# Naval Research Laboratory

NRL/MR/7441--94-7516

## Digital Mapping, Charting, and Geodesy Analysis Program Technical Review of Vector Smart Map Prototypes 1 and 2

January 19, 1995

Figure 2b. Data content errors in railroad

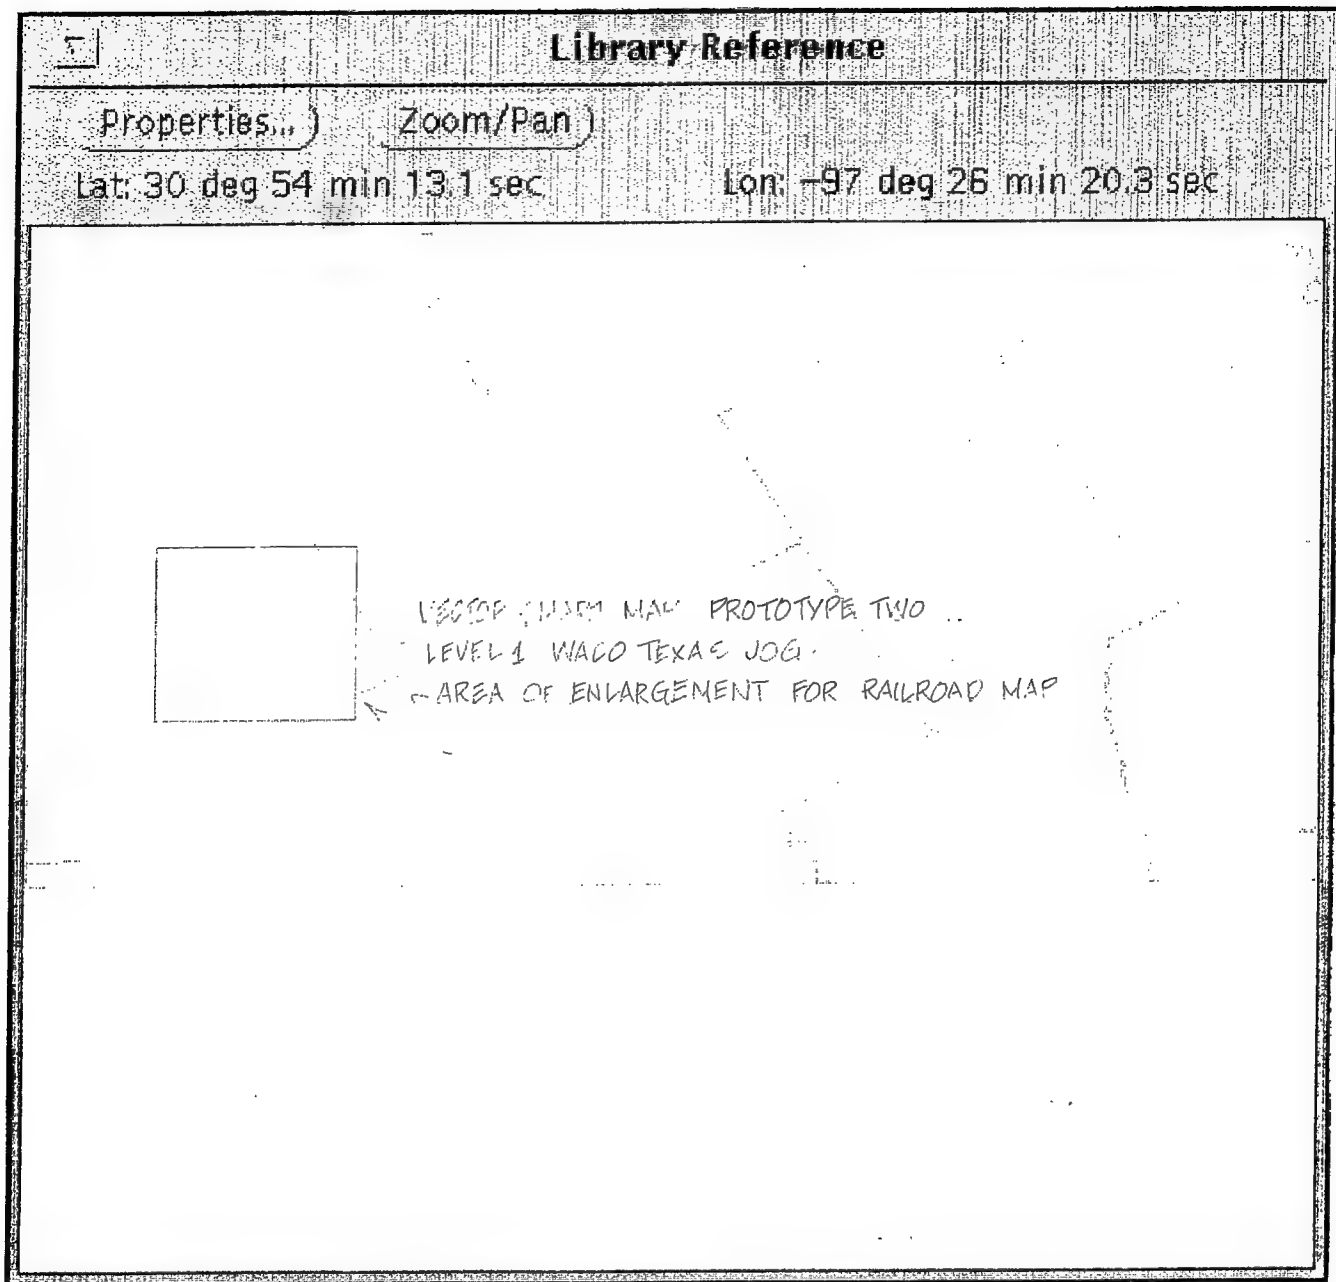
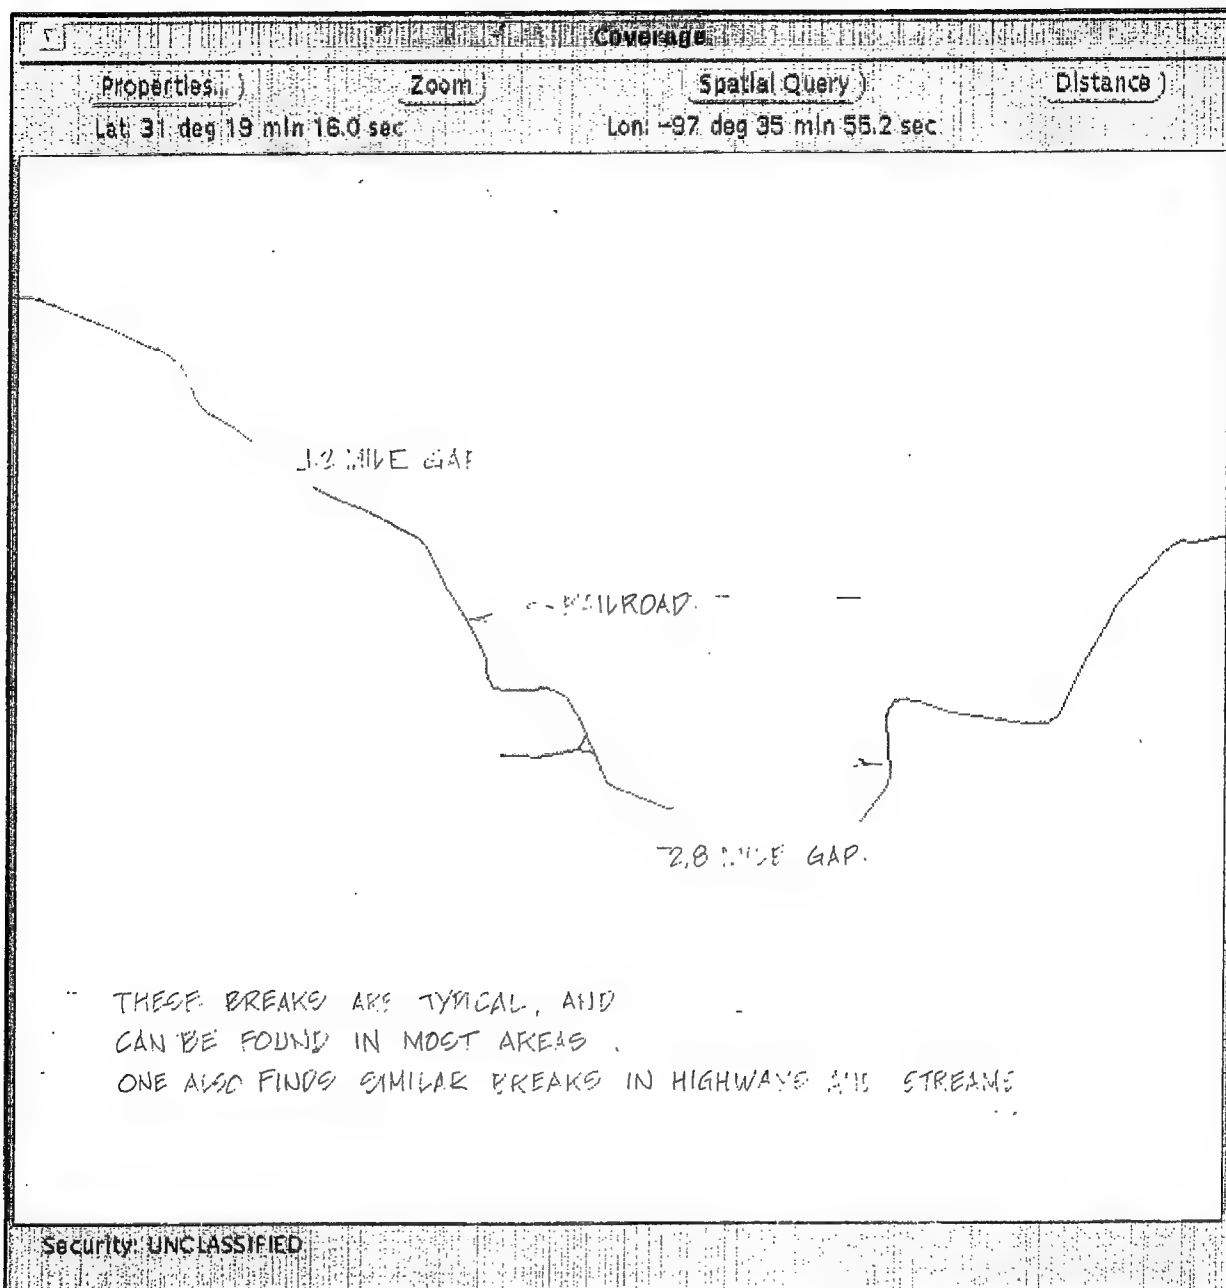
Figures 2a and 2b display an area near Waco and an associated railroad in the Transportation coverage. Unusually large "gaps" are present in the data and could be a result of faulty digitization. Data omission errors and improper registration are displayed in Figures 3 through 5. The circled items in Figure 3 show incomplete "pieces" of roads and data omissions of the railroad in places where a railroad and road are in close proximity. In Figure 4, water courses have clear data omissions. Figure 5 shows apparent shifts in geographical position between the Hydrography and Transportation coverages.

Figure 6a. "Missing" river/political boundary in hydrography coverage

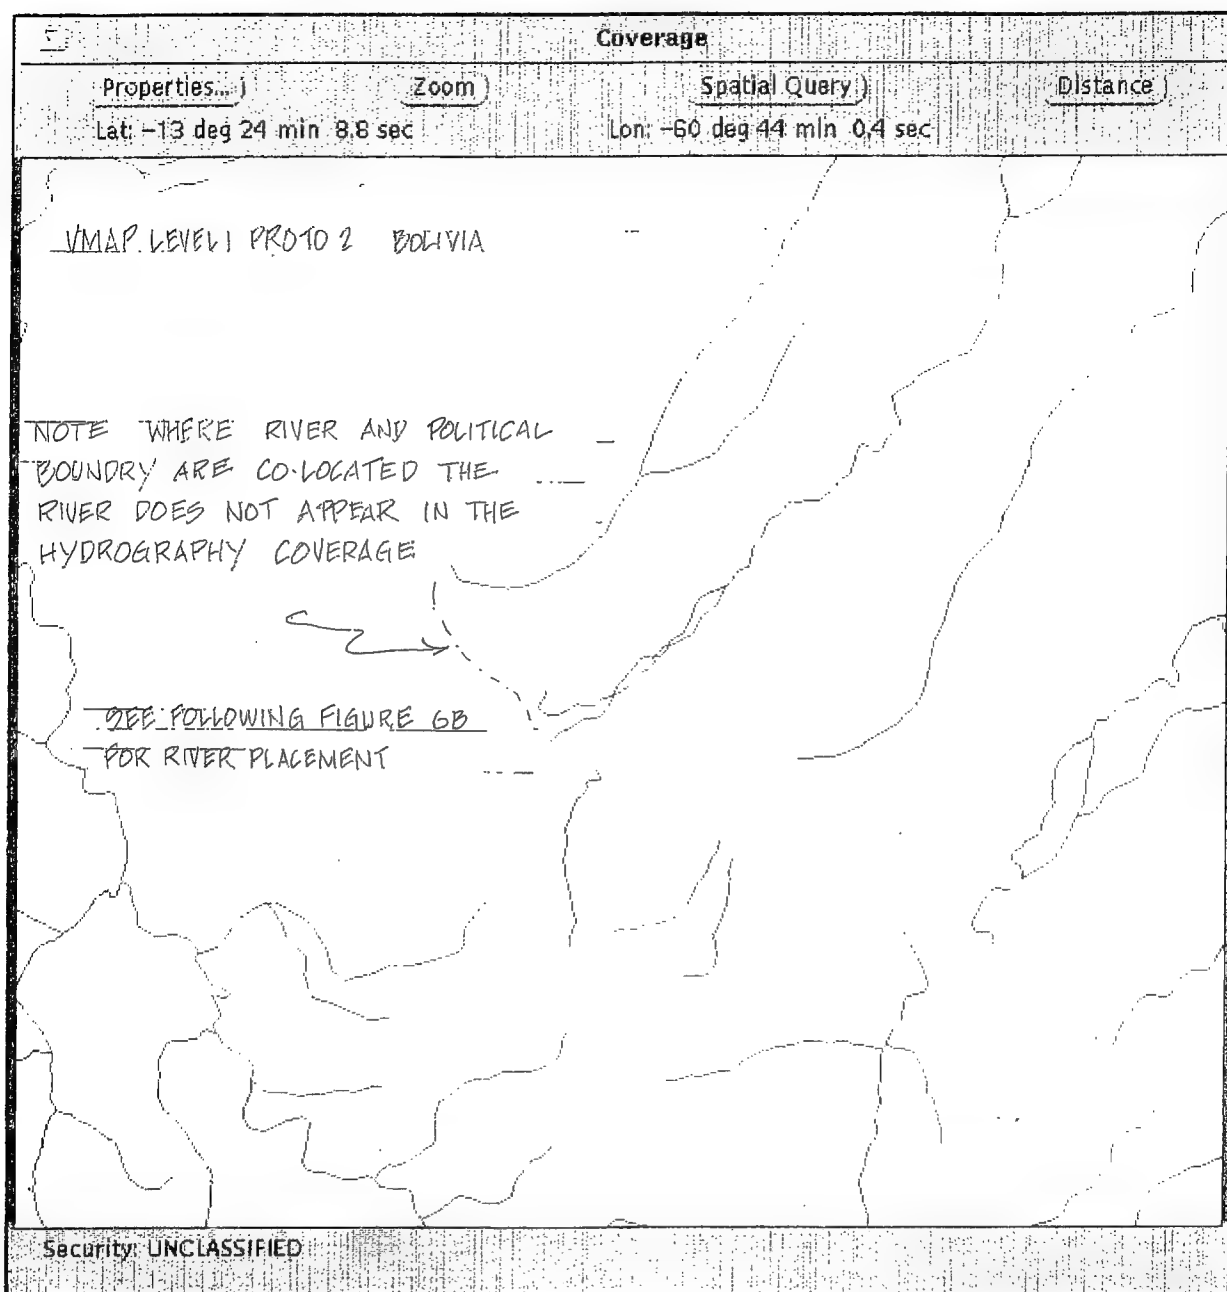
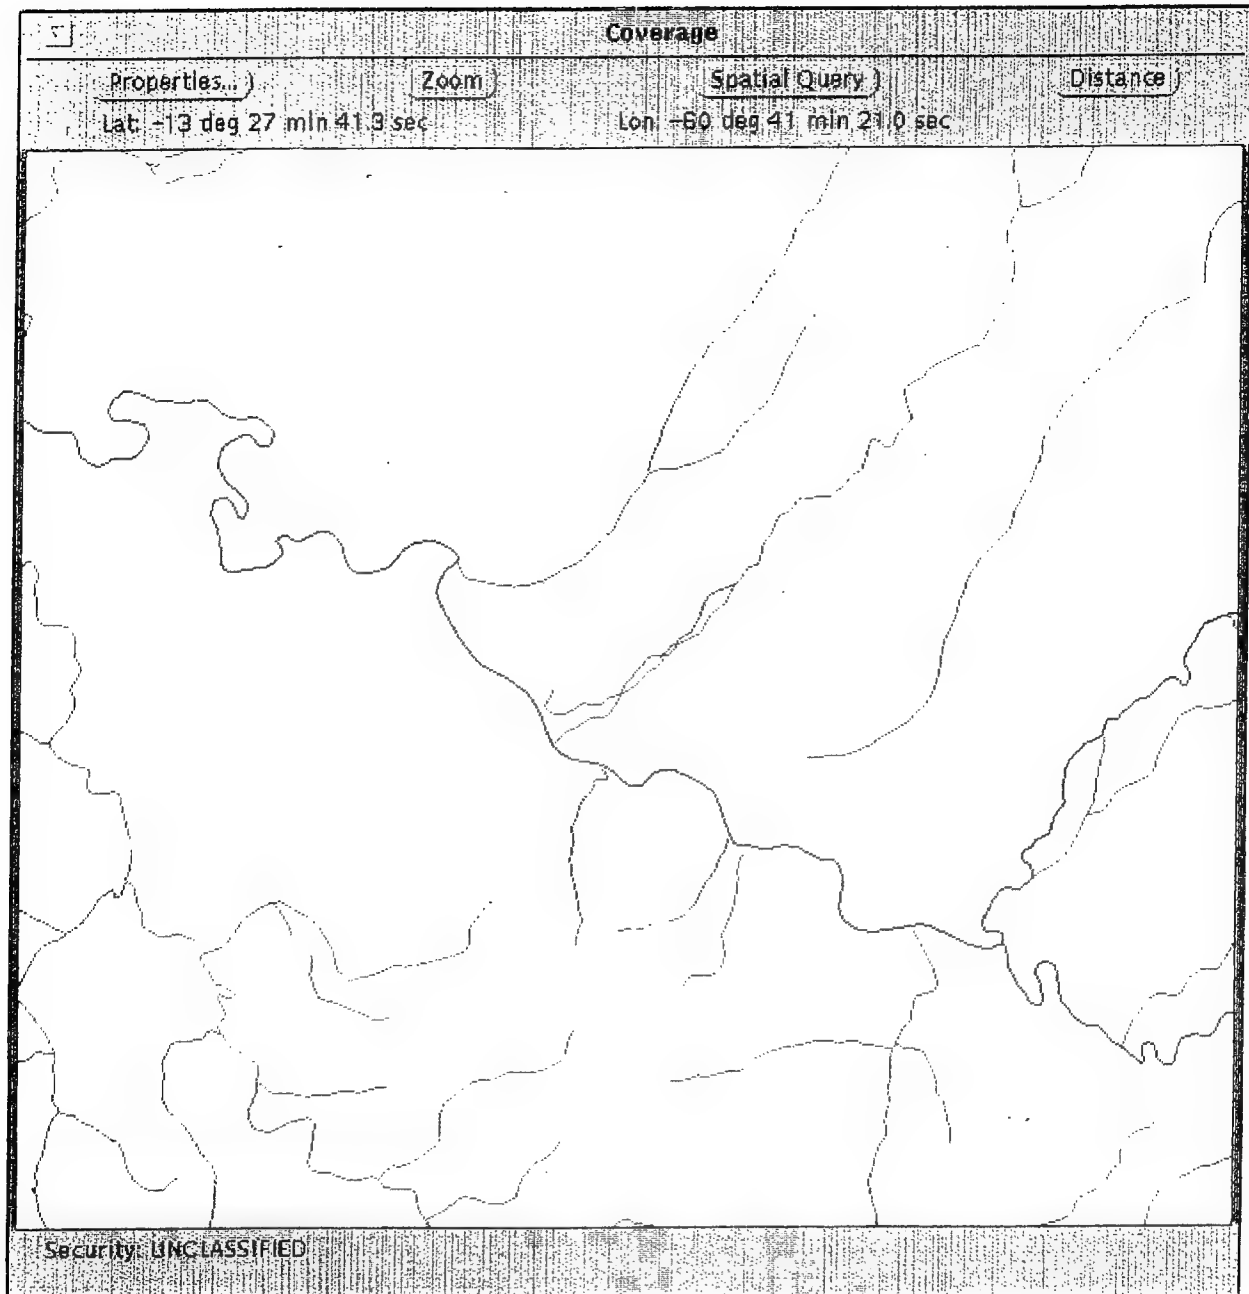
Figures 6a and 6b display water courses from the Hydrography coverage of the medium resolution Bolivia database. The Boundaries coverage political boundary line, between Bolivia and Brazil is determined by a river. This river is not recorded in the Hydrography coverage where one would expect, which caused some confusion. However, upon further study, the river was located in the *area* feature class Water Courses and Bodies in the Hydrography coverage.

Figure 7b. Data content errors in roads/railroads

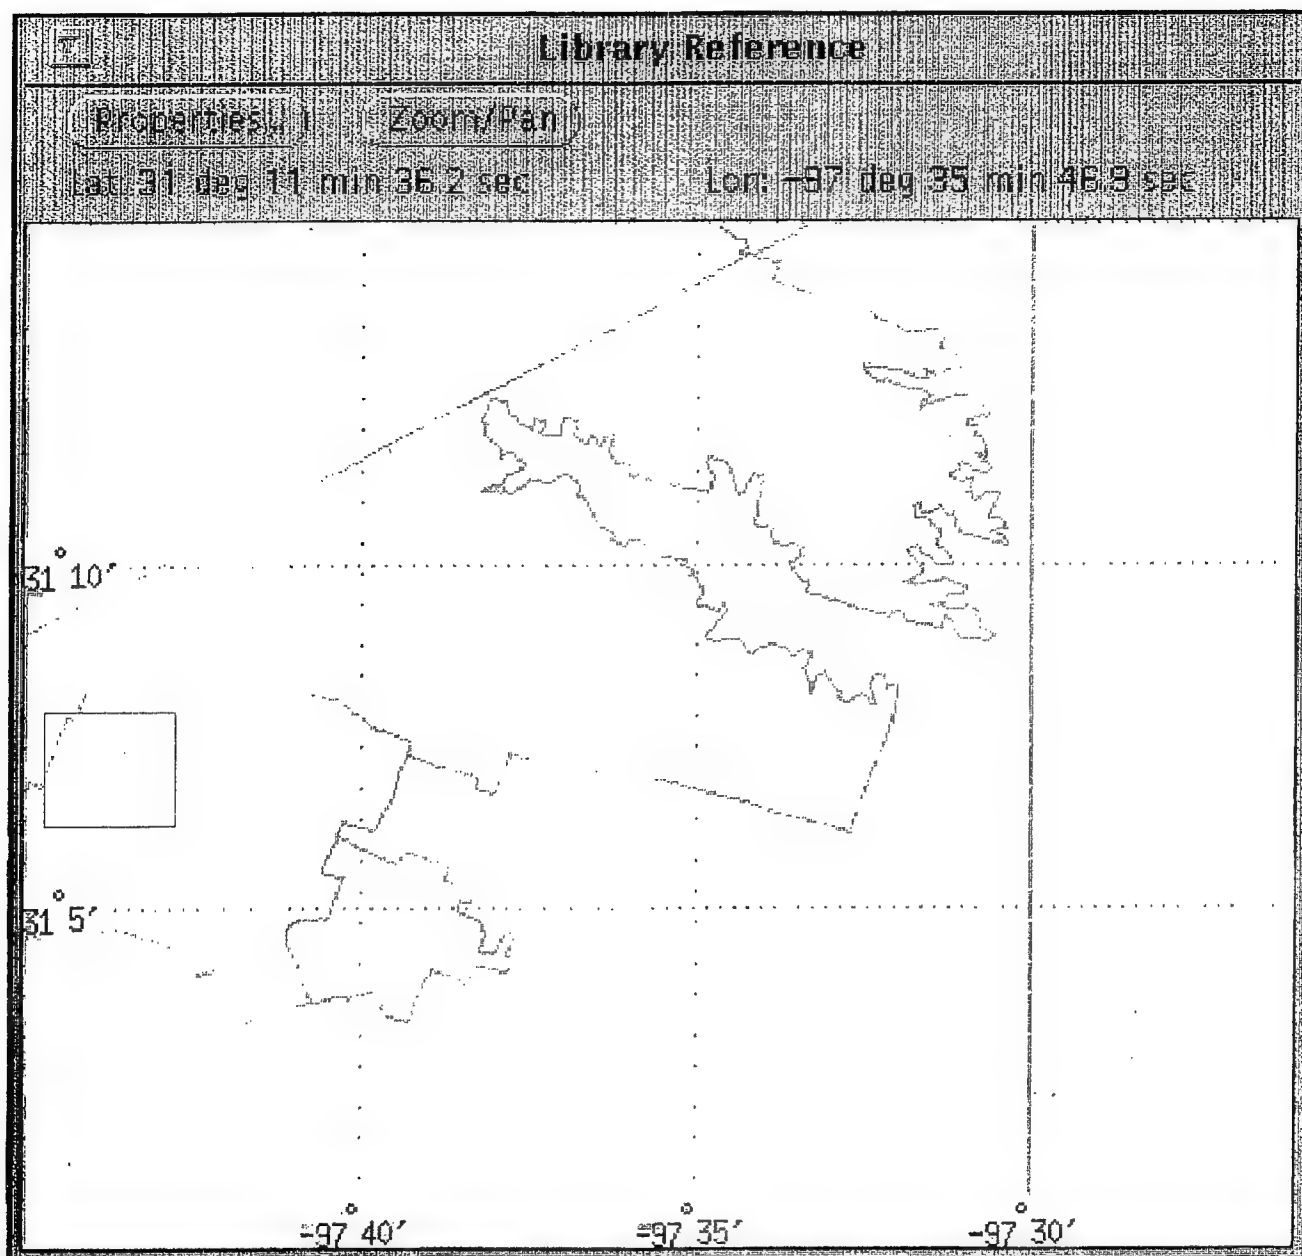
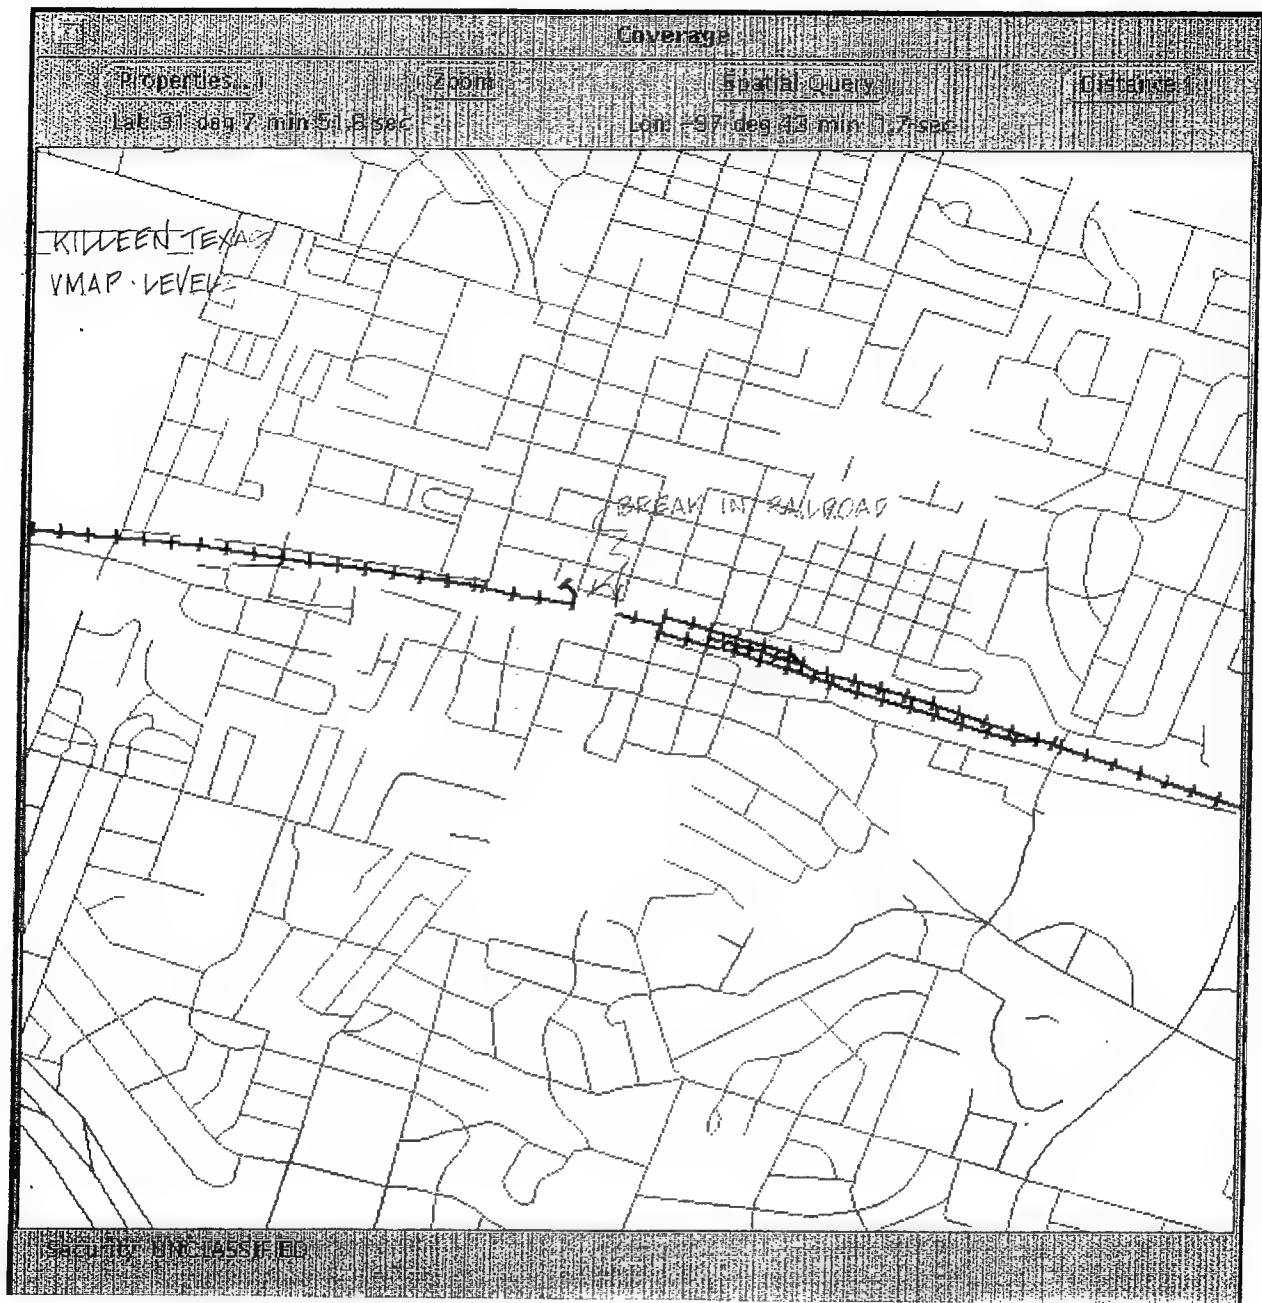
Similar to the medium resolution case, the high resolution data of Texas had several digitization and registration problems. Figures 7a and 7b present one such example (Figure 7a gives the reference area). A railroad from the Transportation coverage is displayed, together with the feature class Roads in the city Killeen. This railroad (Name: Atchison Topeka and Santa Fe) is operational but has a "hole" in the data, as indicated in the figure. Additionally, some roads appear to be disconnected, which seems to indicate incomplete data.
